Work Order ID 136771***136771***

Item Name: Wearplate Center

Reference: REWORK PER ECN 14-628

D3847-045 AFT WEARPLATE ASSY

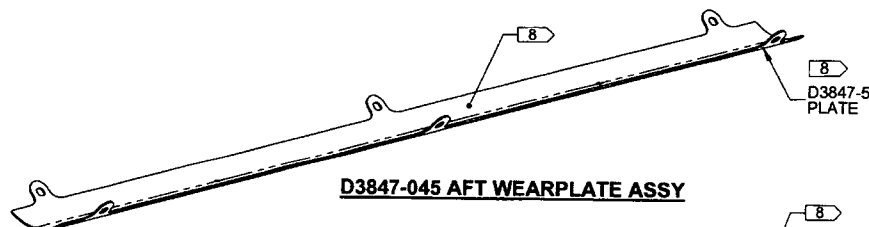
BRING TO ANDY TO REMOVE GASKET, CLEAN AND REWORK TO
APPLY ROCK GUARD PER ECN 14-628**P.T.O.**

APPLY TEXTURE COATING ON TOP CONCAVE SURFACE AS PER DWG

C	REMOVED D3846-3/-5/-7/-9 GASKETS, ZN D2-1, ADDED TEXTURED COATING, ZN B3-1, UPDATED WEIGHTS, ZN C3-1/A8-2	AK	14.08.06
B	CORRECT TYPO D3847-047 WAS D3847-045, ZN B5-1; 5.82 WAS 6.25 (ZN A4-2); 45.28 WAS 45.71 (ZN B4-5)	RF	09.06.30
A	NEW ISSUE	RF	09.03.30
REV.	DESCRIPTION	BY	DATE
DESIGN	RF	DART AEROSPACE USA, INC. KENT, WA	
DRAWN	AK		
CHECKED	VS	DRAWING NO.	REV. C
MFG. APPR.	JLM	D3847	SHEET 1 OF 7
APPROVED	HS	TITLE	SCALE
DE APPR.	DS	WEARPLATE ASSY	NTS
DATE	14.08.06	COPYRIGHT © 2009 BY DART AEROSPACE USA, INC. THIS DOCUMENT IS PRIVATE AND CONFIDENTIAL AND IS SUPPLIED ON THE EXPRESS CONDITION THAT IT IS NOT TO BE USED FOR ANY PURPOSE OR COPIED OR COMMUNICATED TO ANY OTHER PERSON WITHOUT WRITTEN PERMISSION FROM DART AEROSPACE USA, INC.
